ADDENDUM NO. 1

Date: April 14, 2016

Project: **Paving Repairs at Susan B. Anthony ES**

The following is a list of items arising from the pre-bid walk and subsequent bidding questions. All drawing items are clouded and tagged with a Delta #1. There are a total of 20 items included in this addendum.

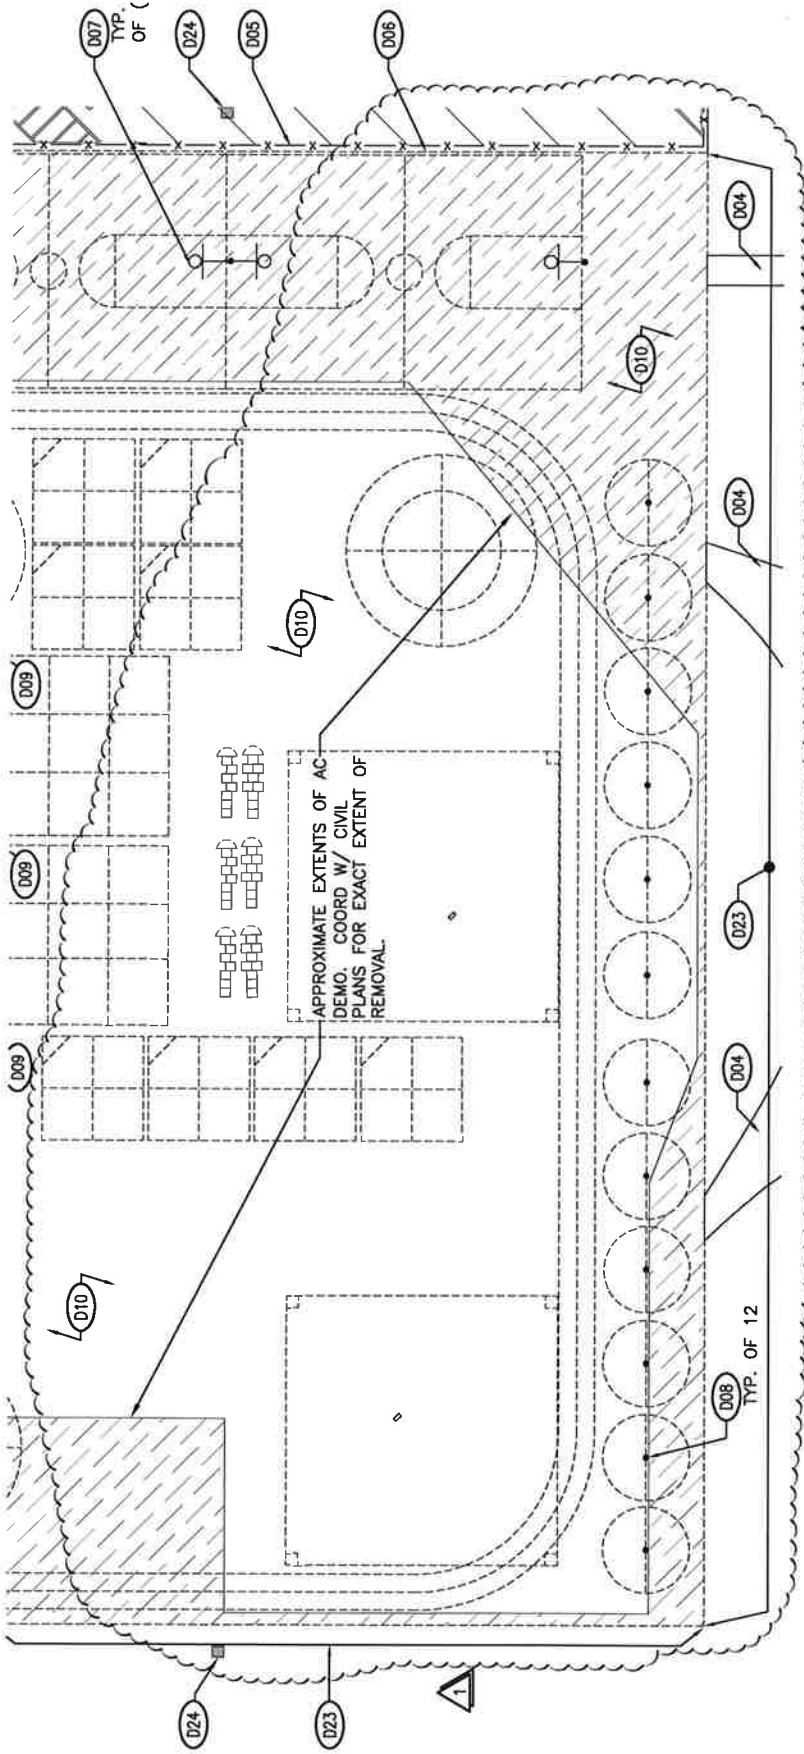
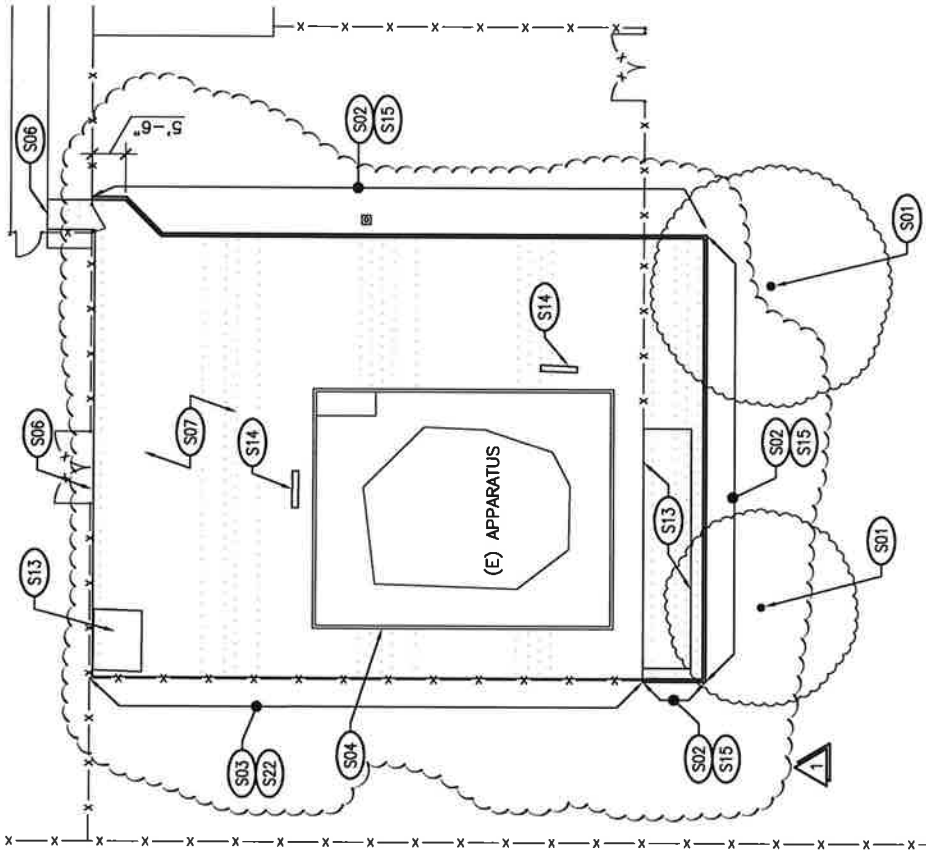
1. Q.: How do I get a copy of the plan holders list and the meeting attendee list?
A.: Bid Walk Sign-In Sheet is posted on our website, <http://www.scusd.edu/construction-projects> and in e-Builder.

2. Q.: Is there a geotechnical report? If so how do we get a copy?
A.: There is not a geotechnical report for this project.
3. Q.: What day would be the most likely start date assuming contracts are fully executed?
A.: June 20th, 2016.

10
 A2 ENLARGED SITE PLAN - APPARATUS AREA
 FILE: SAC5IT_ENL_P

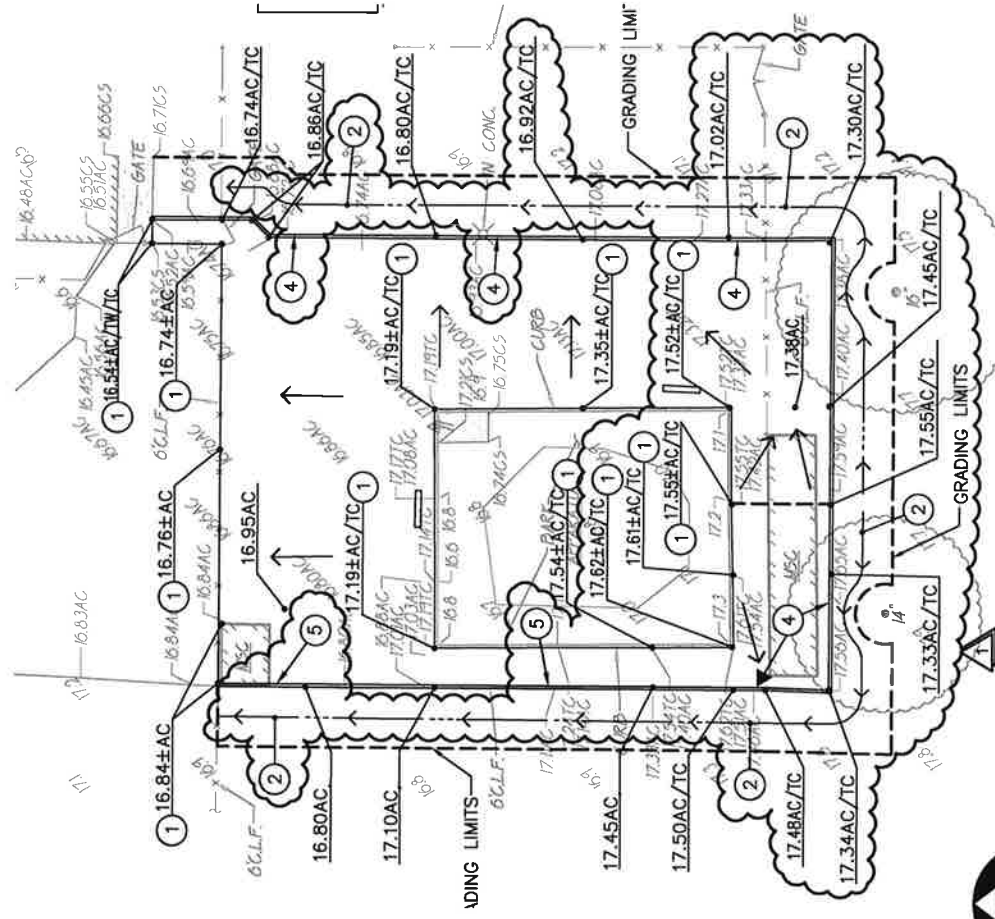
4. Q.: What is the completion date, or how many days do we have to complete the project?
A.: August 26th or 68 days
5. Q.: Due to the 30 day cure time on the AC paving requirement for seal coating, it may not be possible to apply the seal coat before school begins. If schedule does not allow for 30 day cure time can the time of cure be reduced?
A.: The cure time cannot be reduced and will need to be done after school or on the weekend if the project is not completed in time to seal prior to the beginning of school.

6. Q.: See cross hatch pattern on 3D/AD1 that indicates “Grind existing AC as Required...”. Also see Type 1 Paving Area at Hardcourt on sheet C2.1. There are areas shown with full new paving section on C2.1 that are not indicated to be ground/removed on sheet AD1. Which plan governs?
A.: C2.1, the new work plan governs. All demo (means and methods) shall be included in the base bid to accomplish the new work.

15-227 C1.1 A

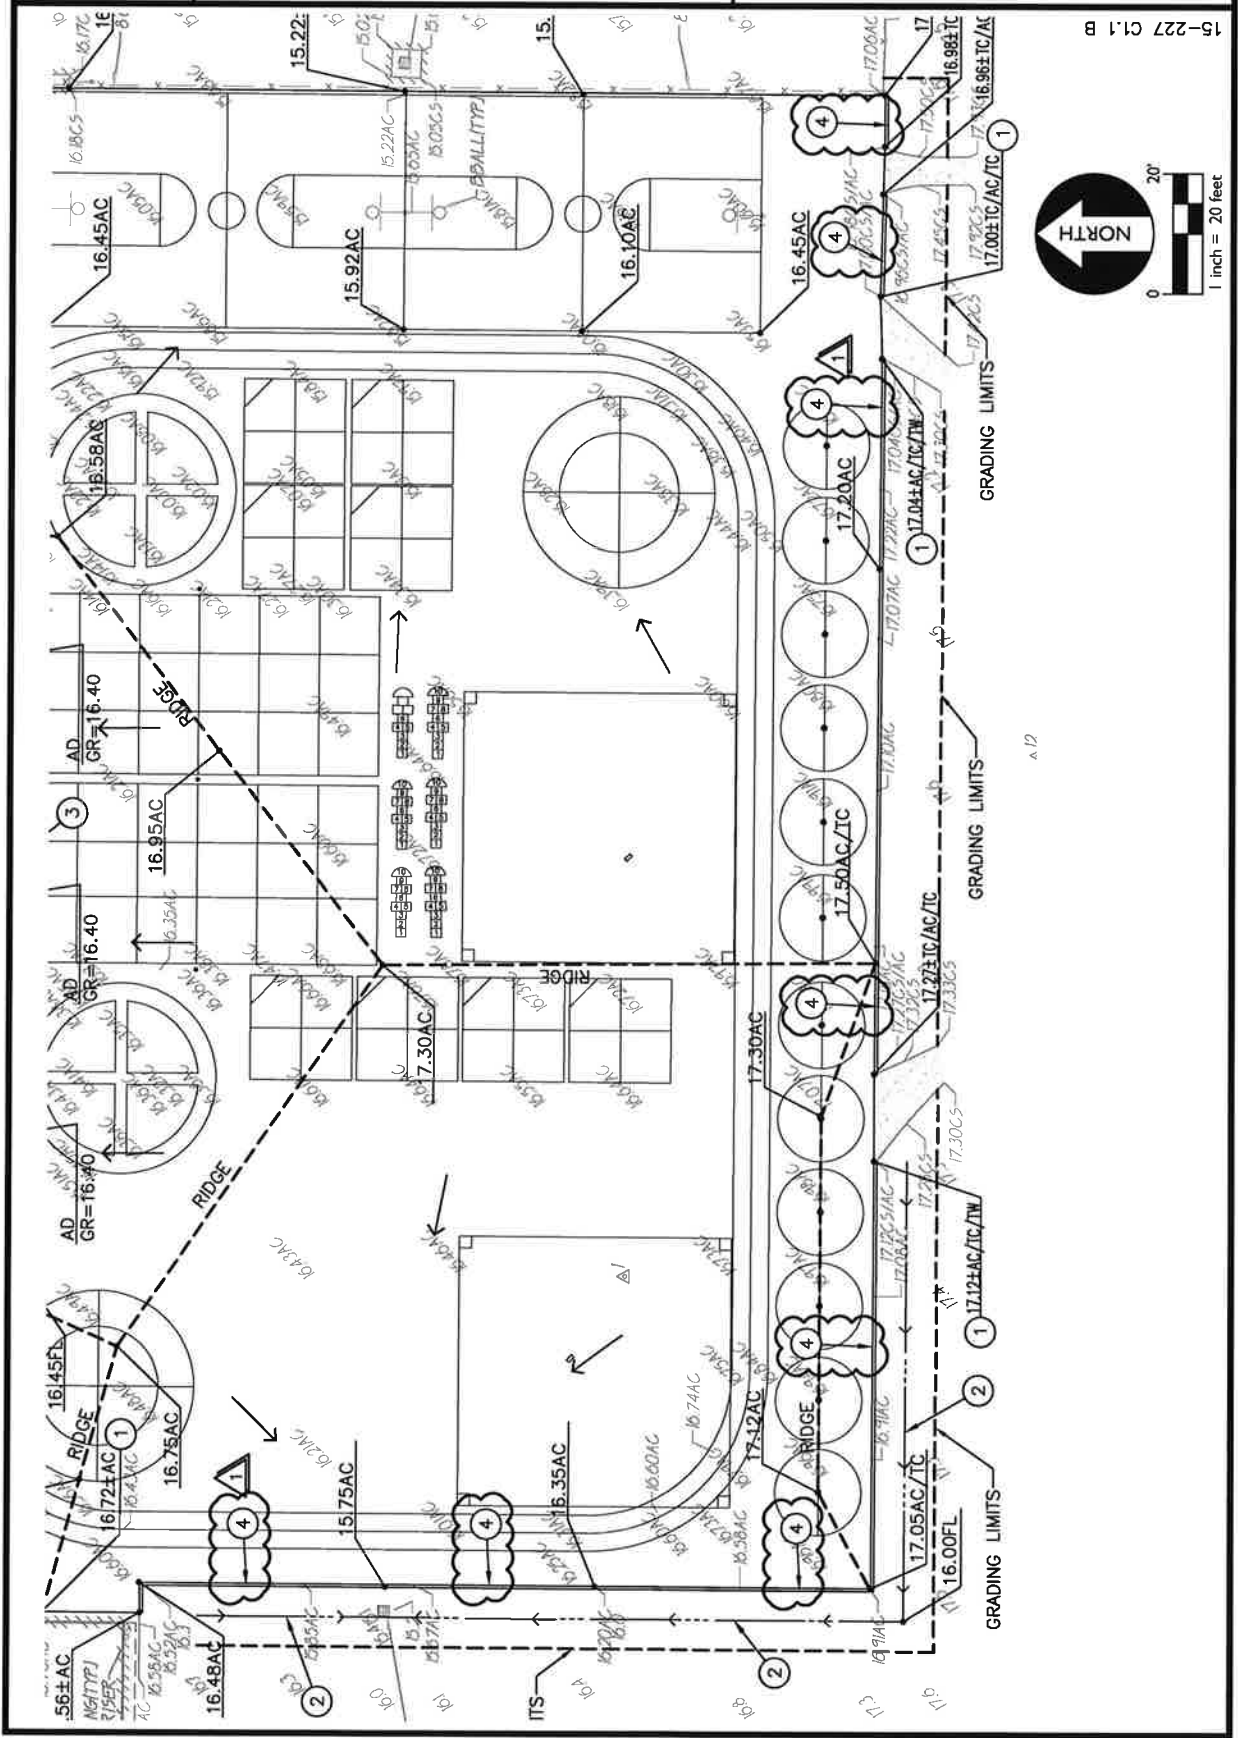
7. Q.: See sheet C1.1. In the paving areas that are to remain but receive a minimum 1.5” thick AC overlay, do the design grades allow for 1.5” overlay minimum or will some cold planing be required to achieve this minimum thickness?
A.: The majority of AC requiring an overlay is 1.5” and greater. Some grinding (cold planing) should be anticipated.

15-227 C1.2 A

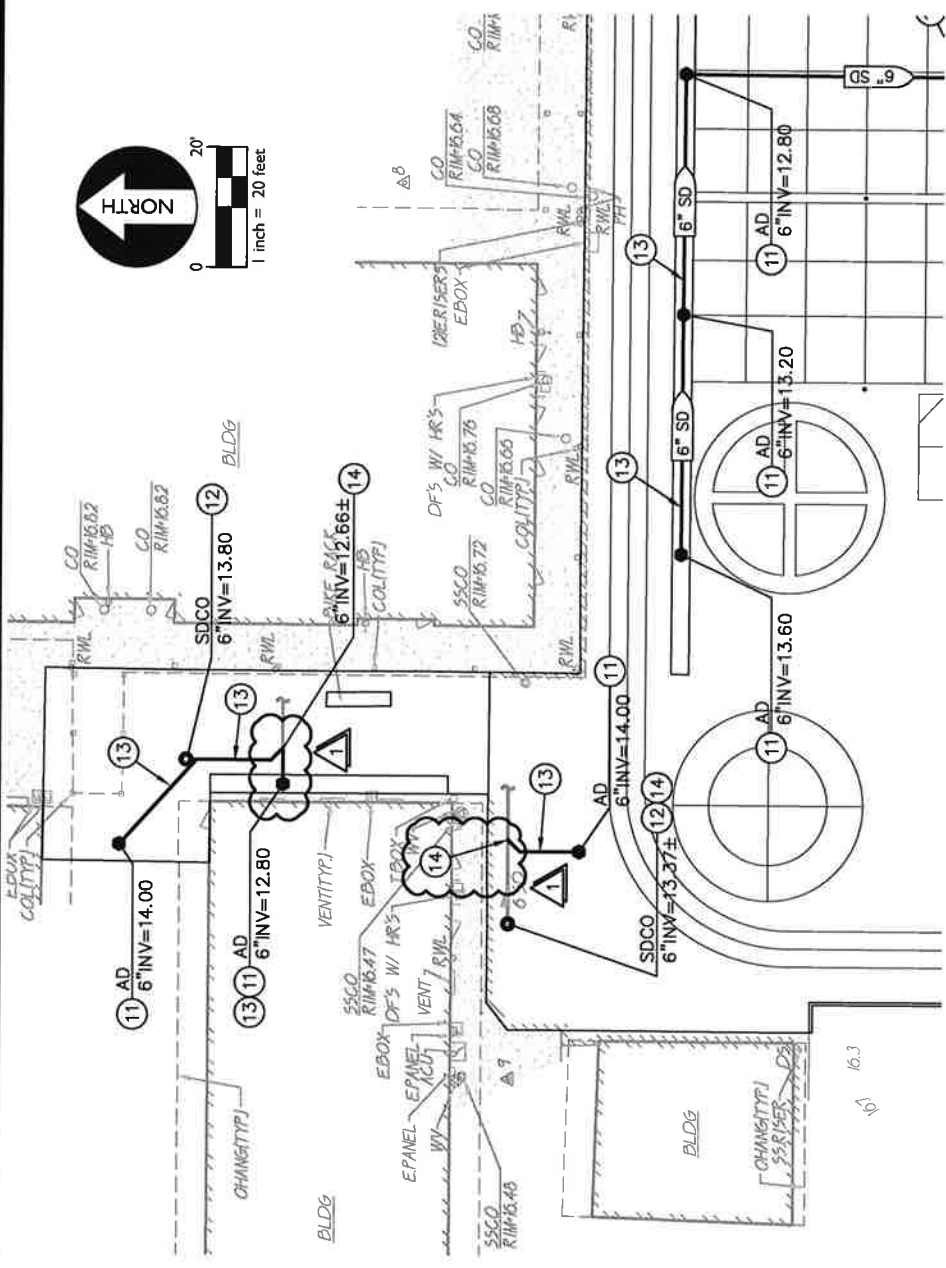
10. Q.: See specification 32 12 00 2.01E, in what locations will 1/2” maximum gradation AC be used?
A.: 1/2” max will not be used on this project.
11. Contractors are to identify all work associated with the “Apparatus Area” plans 1D/AD1 & 1D/A2 as an additive alternate to the bid.

15-227 C2.1 A

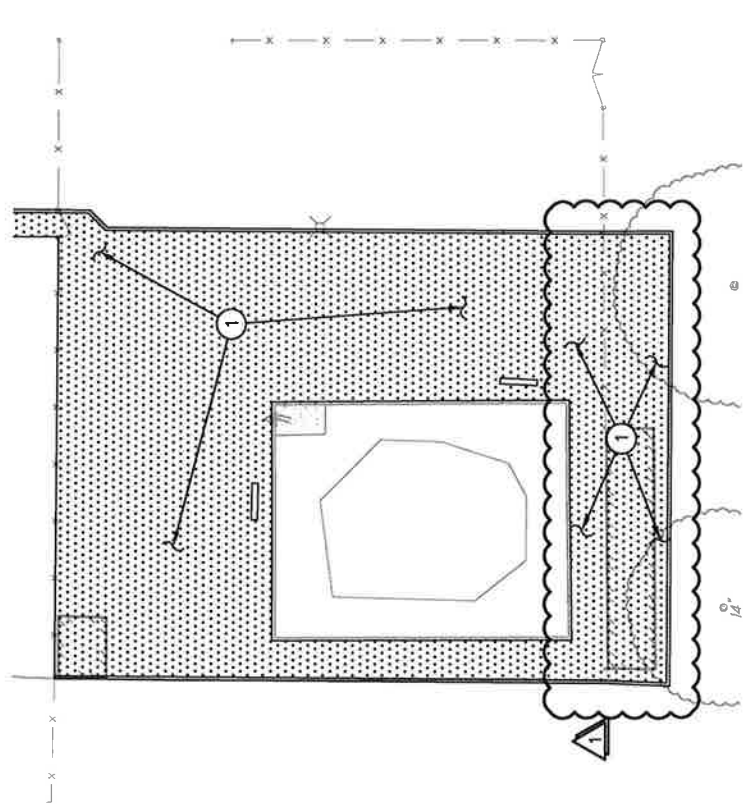
12. Plan 1D/AD1:
Removal of storage container called out.
Removal of a portion of the chain link fence on the south side called out.
AC paving south of the fence line called out for demo.
